1	产品编号	Plastic mould 12035.03 (M2-2)
2	产品名称	12035.03
3	数据版本	V1
4	产品大小(mm)	31X12X114
5	产品壁厚(mm)	
6	产品材料	LDPE-30%/寒冷剂+发紫外线剂+ 色 料-8%/POLYPROPYLENE-62%
7	产品收缩率(%)	
8	产品表面处理	抛光

## 2 P.L 确认

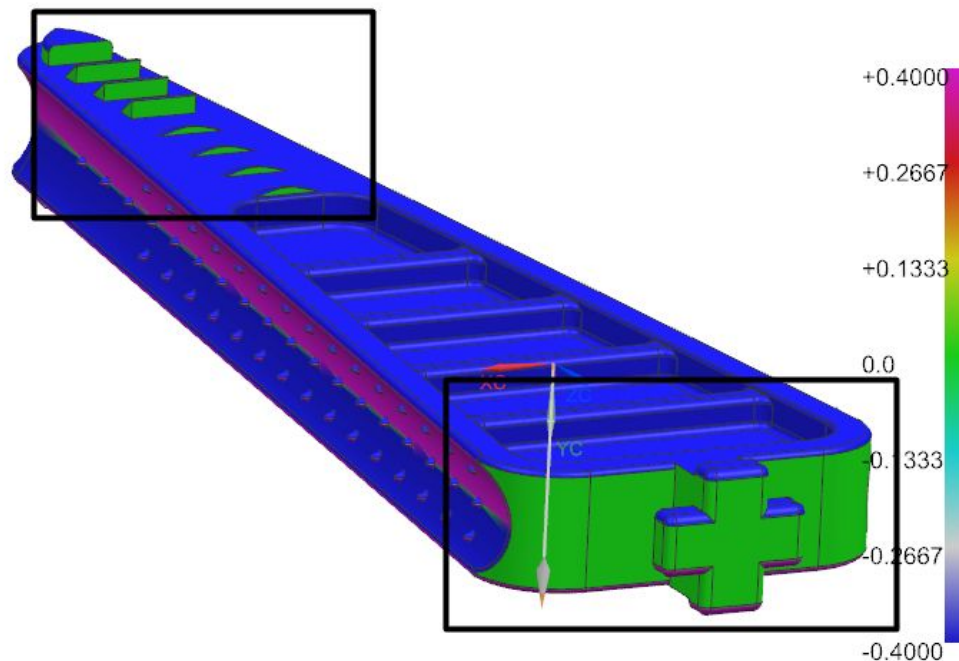
红色线为产品分型线，请确认。  
The red line is parting line, please check it.

## 4 壁厚分析

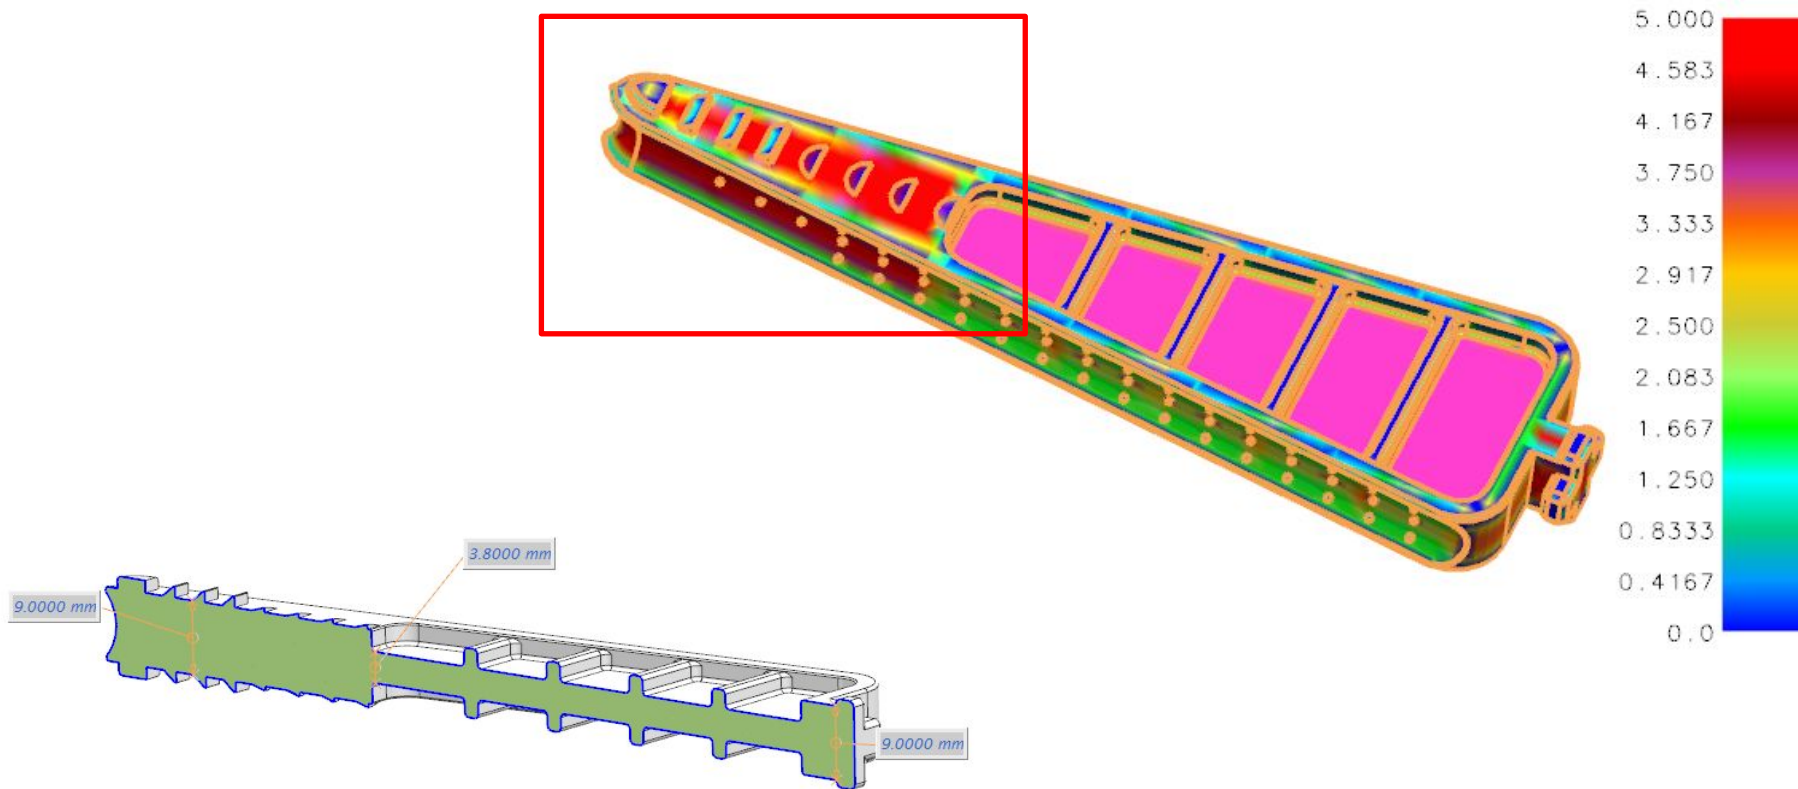
产品壁厚如图分布。  
The thickness of product is shown as picture.

## 5 缩痕分析

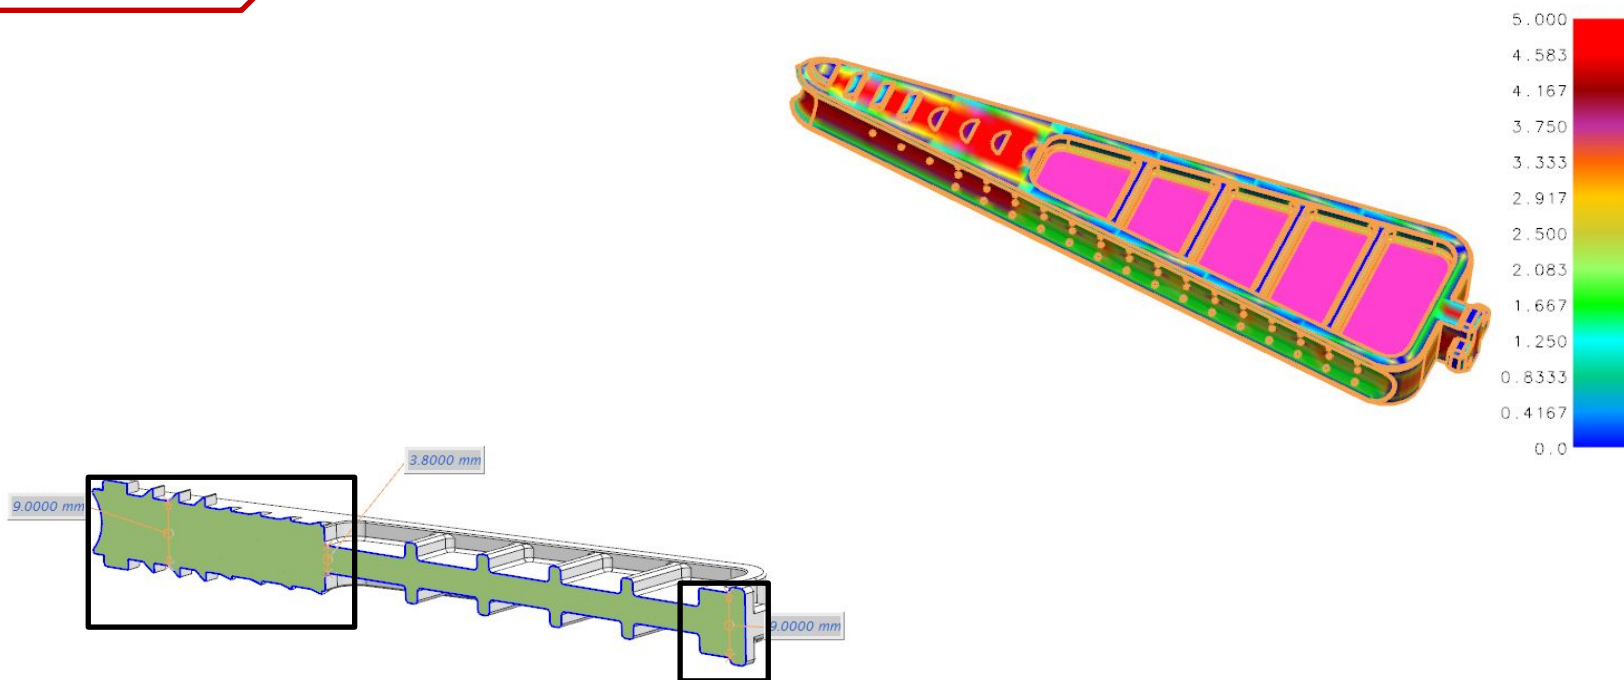
产品壁厚引起的缩痕, 确认是否可接受。

There will have sink mark due to thick thickness, please check whether it is acceptance.

## 6 产品与图纸对比

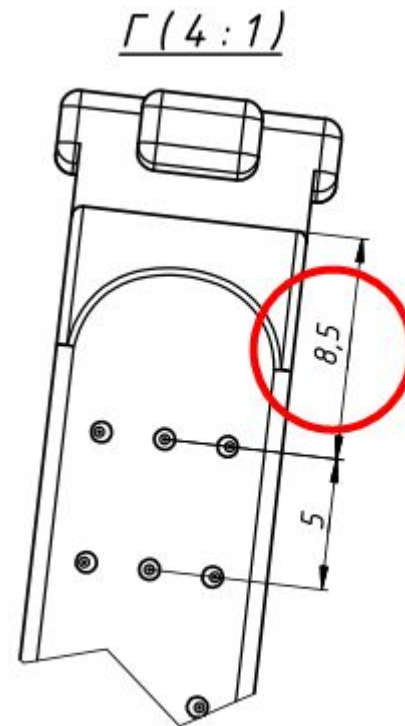
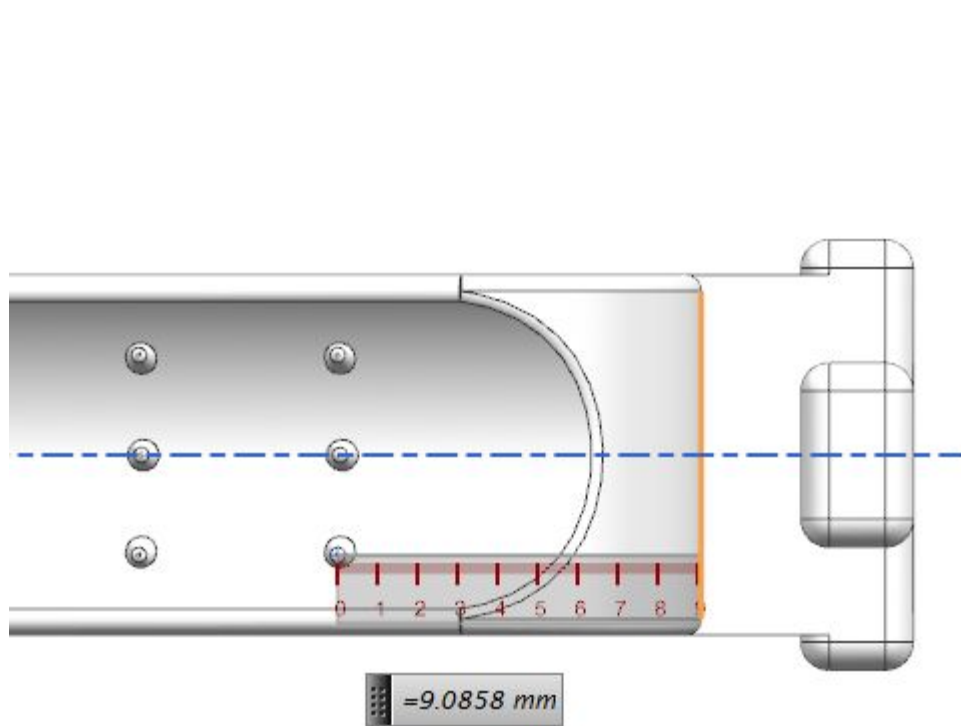
产品与图纸对比存在误差, 请确认

There are difference between 3D data and 2D drawing. Please check which one is correct.

## 7 产品与图纸对比

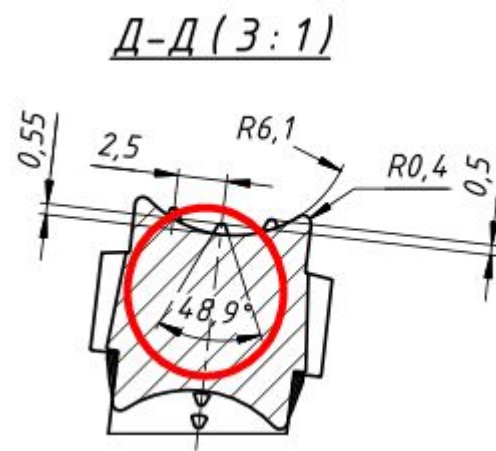
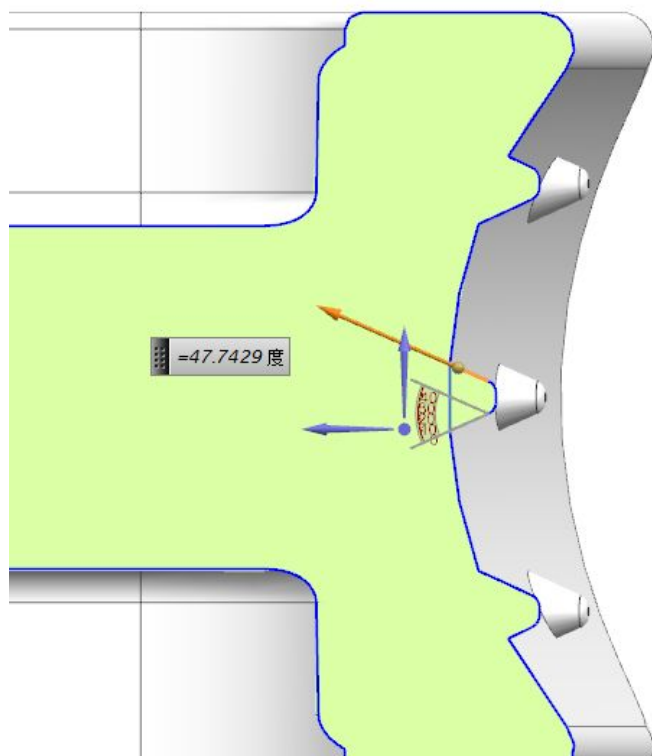
产品与图纸对比存在误差, 请确认  
There are difference between 3D data and 2D drawing.  
Please check which one is correct.
